**PROPOSED SOCIAL WELFARE FACILITY (RESIDENTIAL CARE HOME FOR THE ELDERLY) IN  
“VILLAGE TYPE DEVELOPMENT” ZONE ON APPROVED NAM SANG WAI OUTLINE ZONING  
PLAN NO. S/YL-NSW/10 AT LOTS 3670 RP (PART), 3671 RP (PART), 3672 RP (PART) AND 3673  
RP (PART) IN D.D.104, NAM SANG WAI, YUEN LONG**

**Town Planning Application No. A/YL-NSW/349 - Submission of Further Information (9)**

# Consolidated Planning Statement

T:\JOB\J7400-J7449\J7401\2025 07\Fig 3.1 - 3.2 RevB.dwg

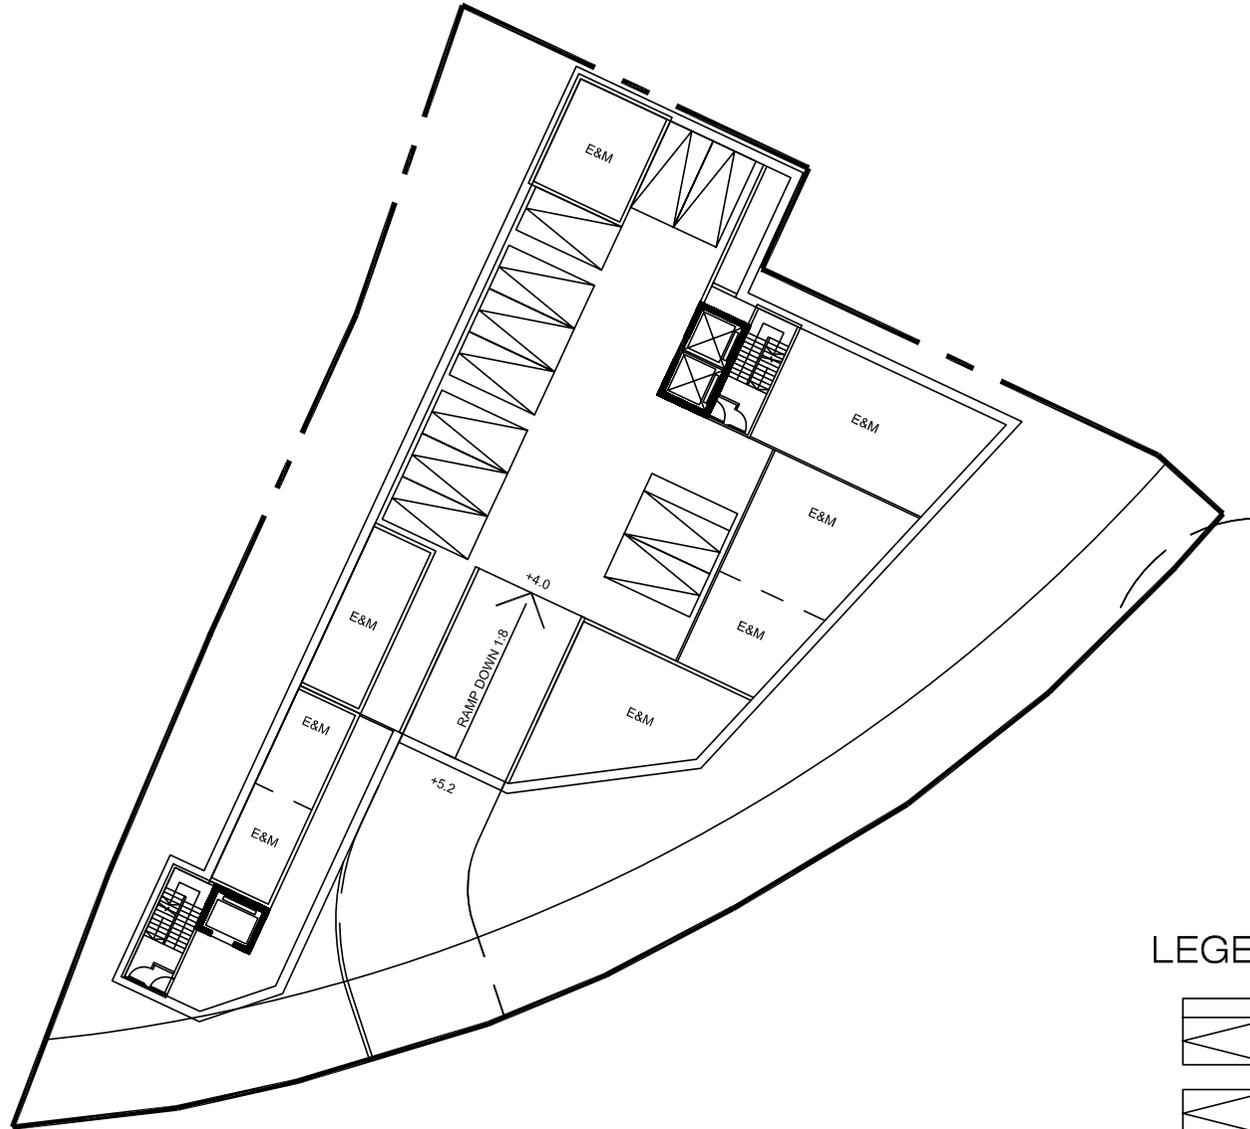
| 5.  | In the site entrance, please provide a clear segregation between vehicles and pedestrians from road safety perspective. For the proposed pedestrian entrance in the building in Figure 3.1, apparently pedestrian is expected to walk across the vehicle manoeuvring area (i.e. light/ambulance, LGV, PCs/taxis) which poses a safety concern. Please review. | Pedestrian entrance provided for the Proposed RCHE is separated from the manoeuvring area. Please refer to the <b>Figure 3.1</b> in the revised TIA report.  |

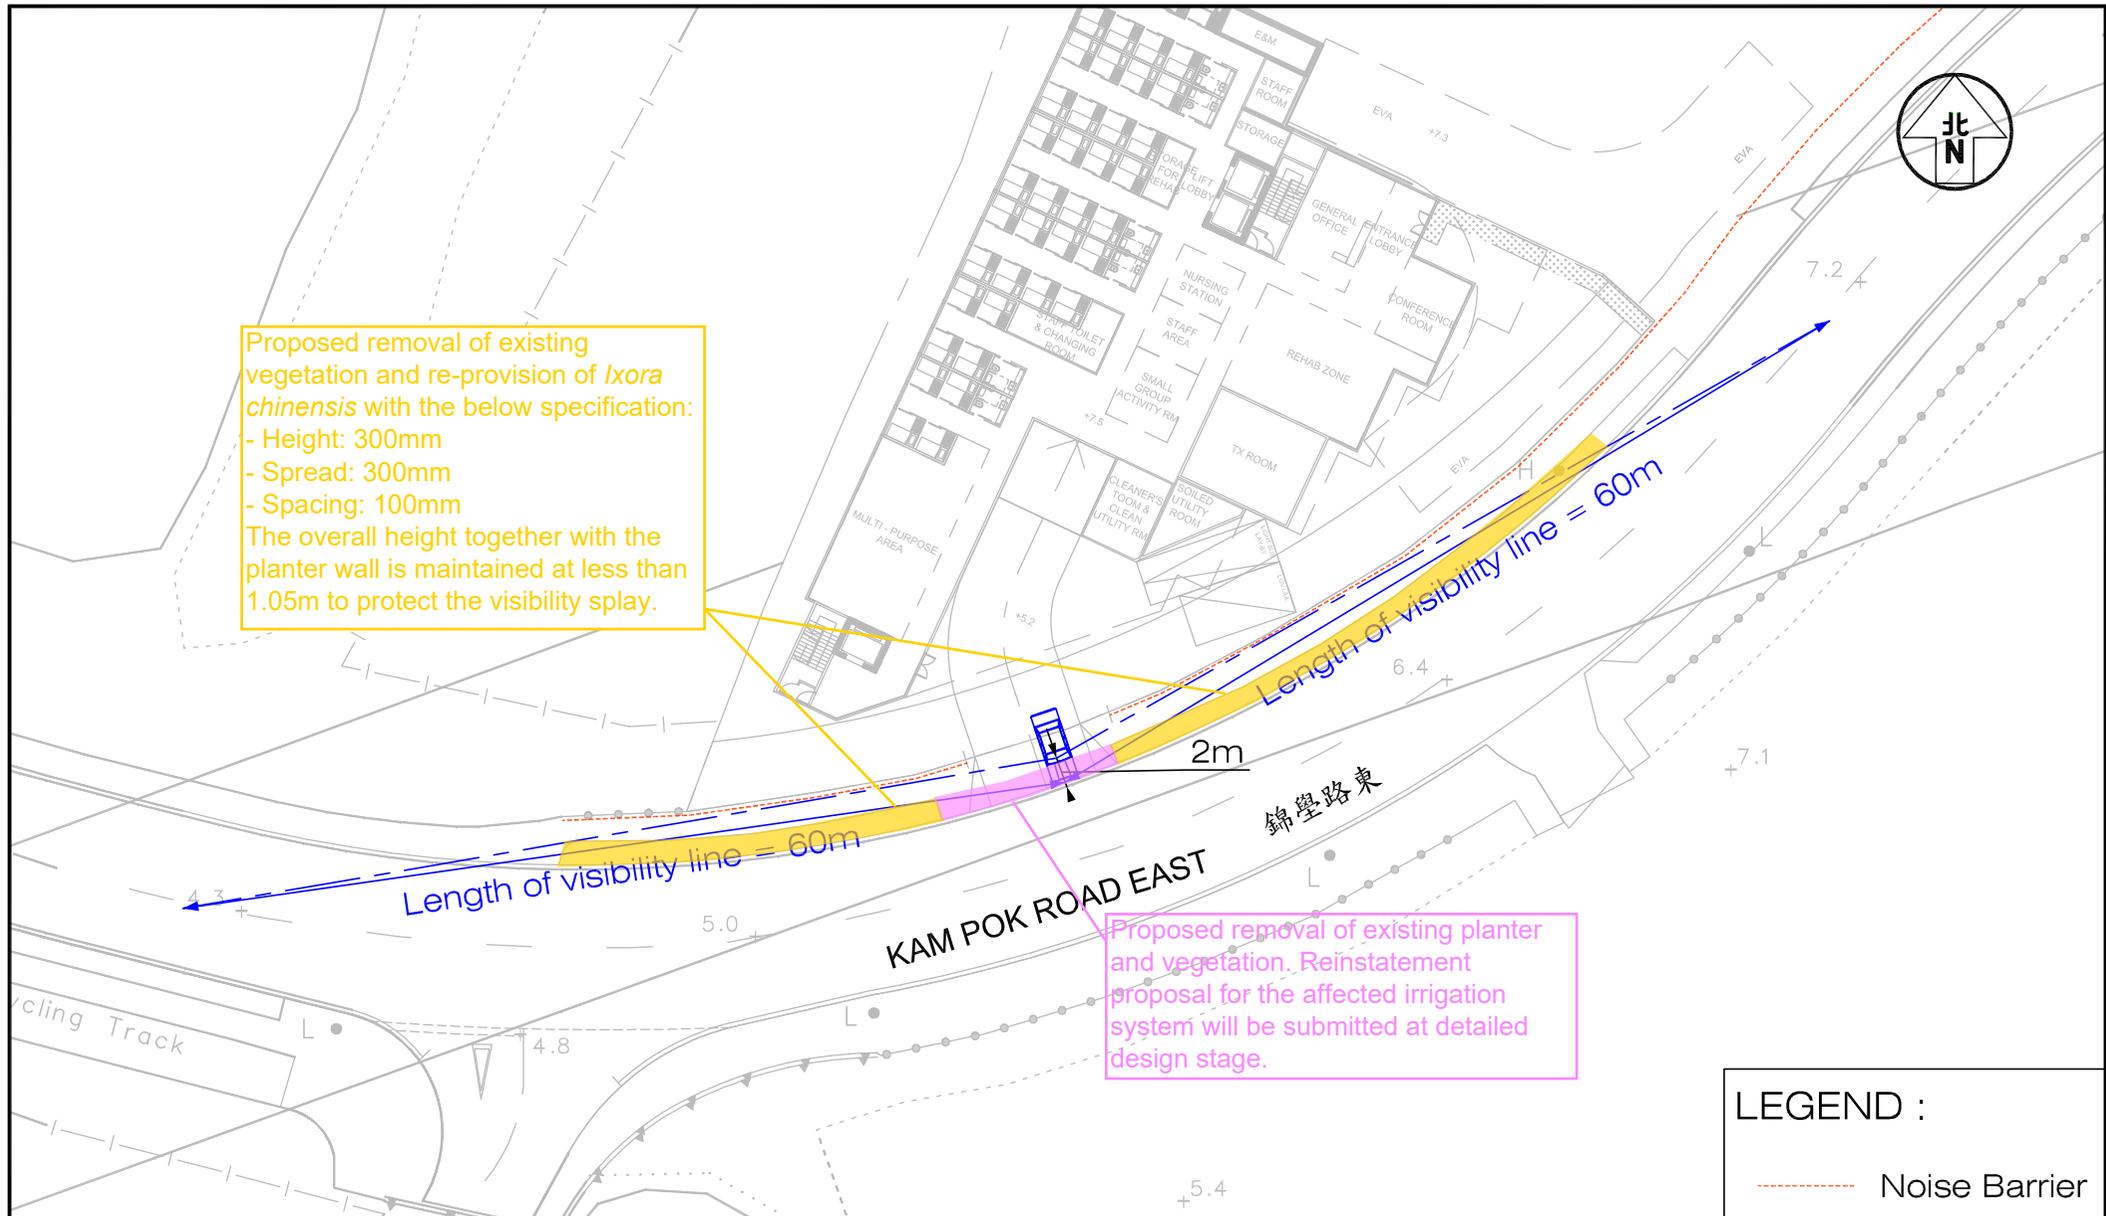
| 6.  | Figure 3.3: Unless otherwise agreed by the relevant departments including but not limited to EPD and HyD that the existing noise barrier can be demolished, please demonstrate adequate sight line can be provided at the ingress/egress with the presence of existing noise barrier.   | The noise barriers have been indicated in the <b>Figure 3.3</b> in the revised TIA. The measured length of visibility splay for the motorists leaving the Proposed RCHE is 60m to the left and 60m to the right, so adequate sight line can be provided at the ingress/egress. The detailed design for necessary alterations of affected noise barrier and planters will be further dealt with at the land exchange stage. |

Figure No. 4.1 Revision C

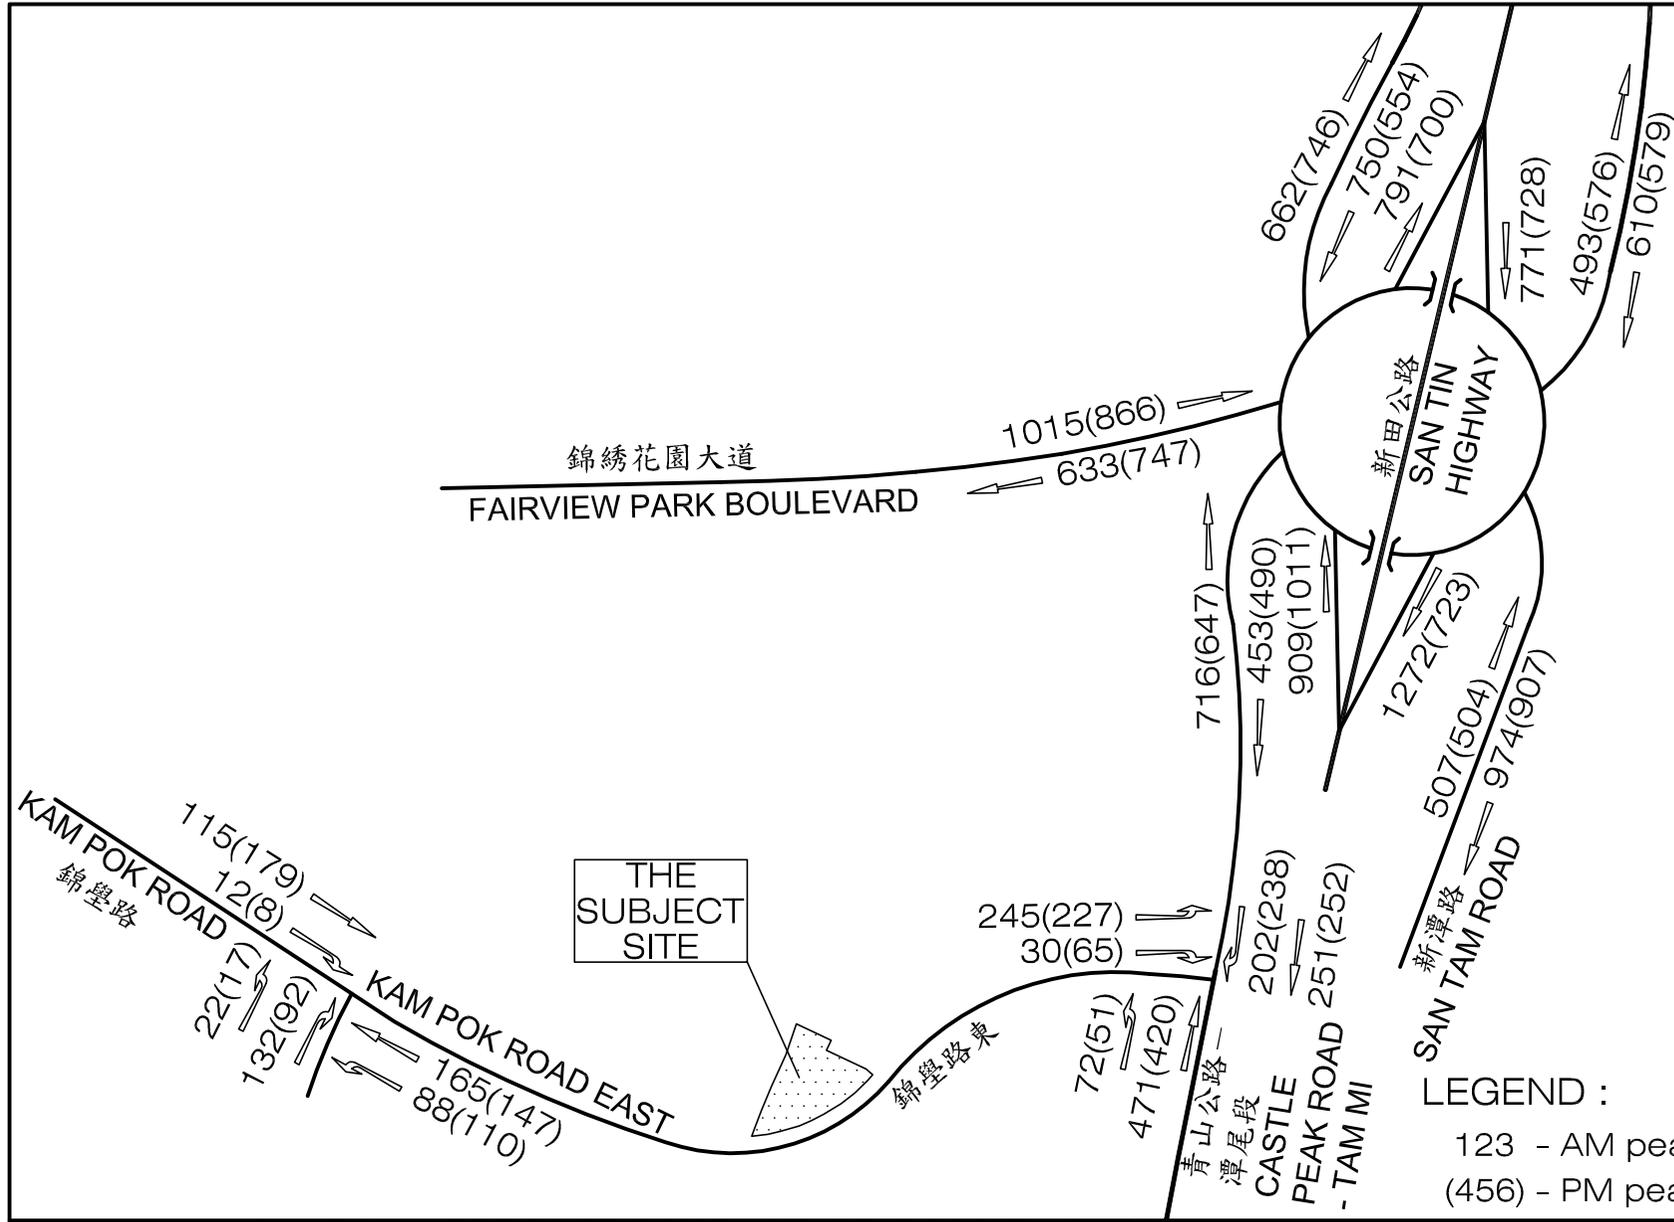
| <ul style="list-style-type: none"> <li>- Please provide a plan showing the vehicular ingress and egress routing to the subject site. Entrance for pedestrian should be shown on plan as well;</li> </ul>  | <p>Noted. Please refer to Figure 4.1 in the revised TIA (Appendix 2) for the vehicular route and Figure 3.1 in the revised TIA (Appendix 2) for the pedestrian entrance.</p>  |

**FIGURE 2.1**  
**LOCATION OF REPRESENTATIVE AIR**  
**SENSITIVE RECEIVERS**

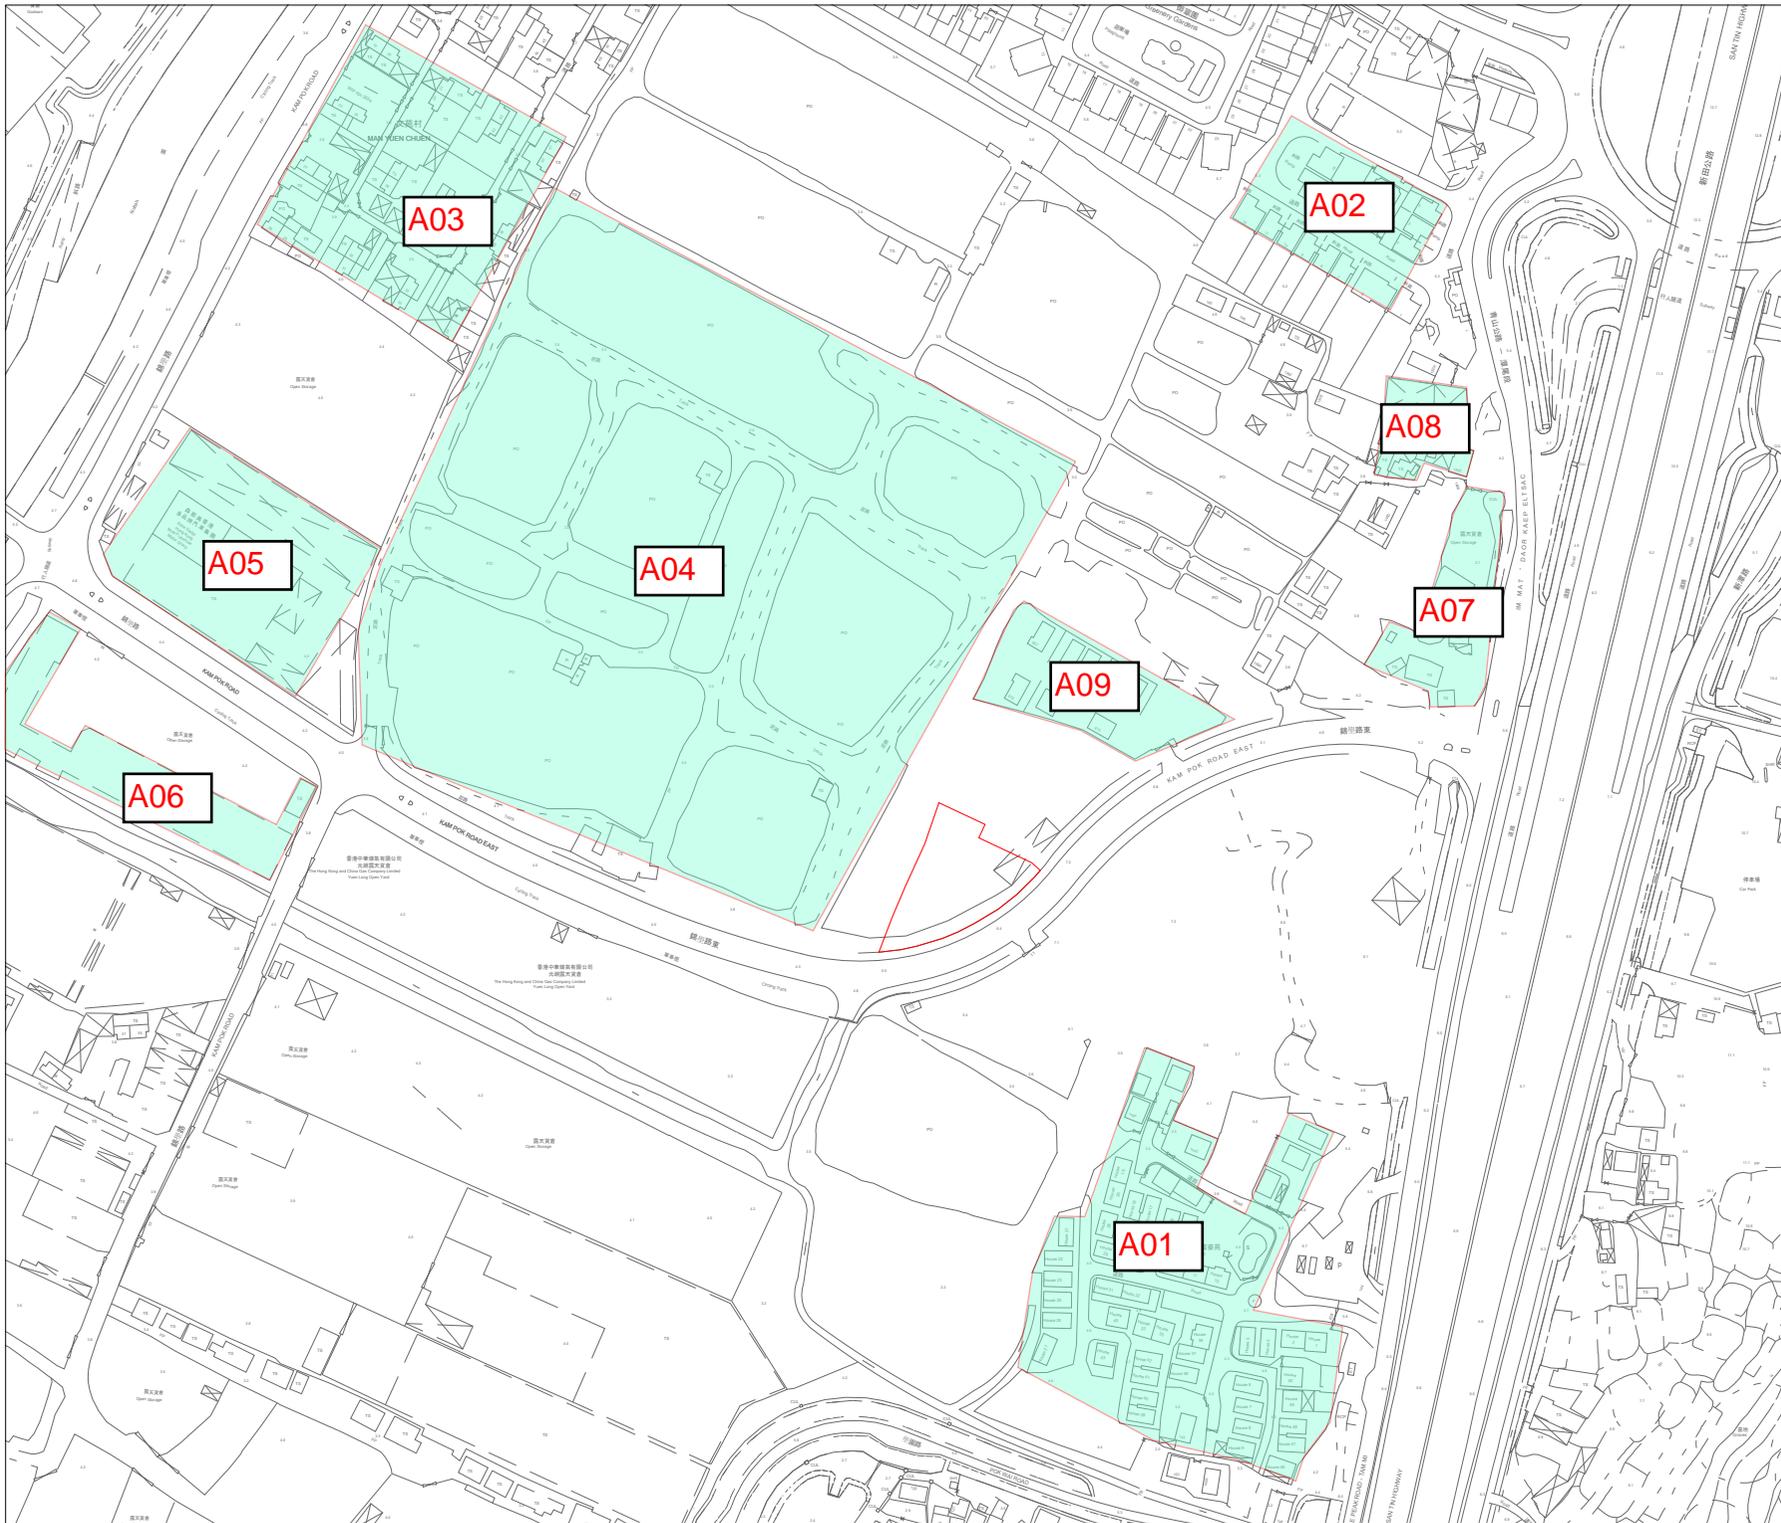
| Departmental Comments   | Response  |
|---|---|
| 3. Section 2.3.1, Table 2.3 and Figure 2.1 - Please note that not only the domestic premises are the ASRs, some places/premises such as factory and workshop may also be the ASRs. Based on the desktop review, there are some areas in the vicinity of the project site which have been used for workshops/open storage, etc. Please review the potential existing/planned ASRs within the assessment area with reference to the Determination of ASR under the EIAO-TM and update as appropriate. | More ASRs have been identified in Table 2.3 and Figure 2.1. For other areas mainly for open storage use where long duration of exposure to air pollutants is not expected are, therefore, not considered as ASR. Please refer to the revised EA (Appendix 1). |
